19 August 2022
Job Reference No. VS21063

S82 Weston – O&M Report [3]

The following is a brief summary of the Residential Waste Management Strategy proposed for B1, S82 Weston. The development consists of 24 buildings across site (Labelled by letters on the Architectural Documentation). The site has a number of satellite Waste Enclosures for resident disposal and two main collection enclosures adjacent the designated collection points.

Figure 1: TCCS/ACTNoWaste agreed minimum circulation path width

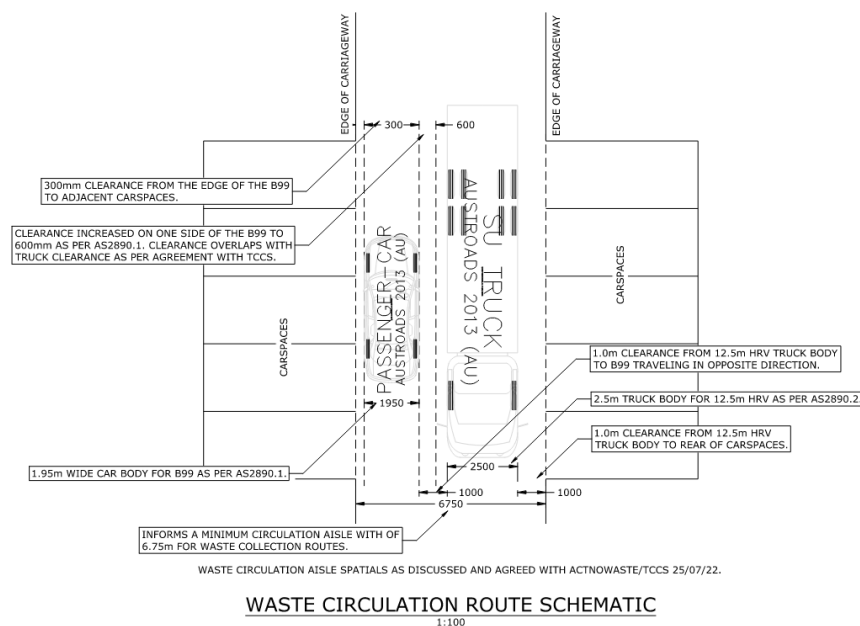
During the meeting 25/07/2022, the swept path spatial requirements were discussed due to ambiguities in the 2019 DCC Code requirements and how they should be applied given the site constraints. The below detail was agreed upon in order to inform the minimum width of the on-site circulation routes used by ACTNoWaste vehicles. Note, in the meeting, Jose Henriquez of TCCS confirmed that this informs the minimum width and there is no requirement to provide additional width at bends, Mike Stelzig of ACTNoWaste was present and there was no objection.

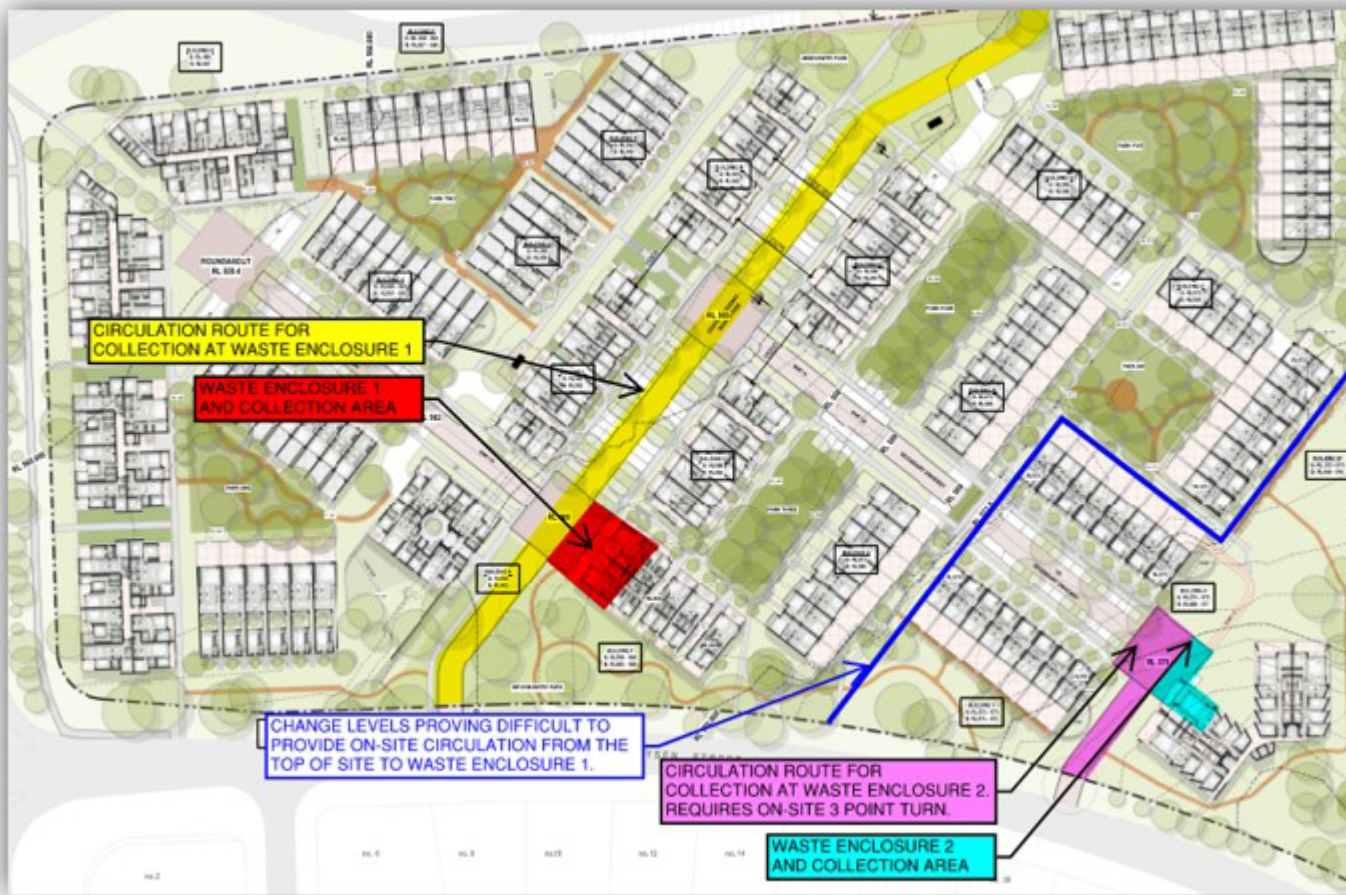
The site design is having difficulty providing internal connections from the upper reaches of site to the lower avenue.

This is due to the extensive fall across site (A total of 22m fall from highest point to lowest)

Due to this, the project team would like to explore 2 Territory Collection points.

- Site remains purely a residential development
- Site remains a single block and section
- Trucks will enter/exit site forward in/forward out
 - o The Eastern location will require an on-site 3pt turn
- Appropriate Waste Enclosures/Waste Collection Areas will be designed at the two collection locations
- Generally the site will comply with the 2019 DCC and our ongoing liaisons

See below markup of the two proposed collection locations.

- Two on-site Waste Enclosures and collection points is permissible for the development

Now with regards to your query below, please note that we're happy to support the two (2) enclosure/collection points as long as:

1. Both enclosures contain waste and recycling hoppers in each enclosure;
2. The carrying distances from units to these enclosures and/or to the closest waste stations onsite does not exceed 75m for standard units and 50m for adaptable units; and
3. All waste requirements are met as required by our waste code including provisions for our trucks to turn around onsite with no more than a three (3) point turn.
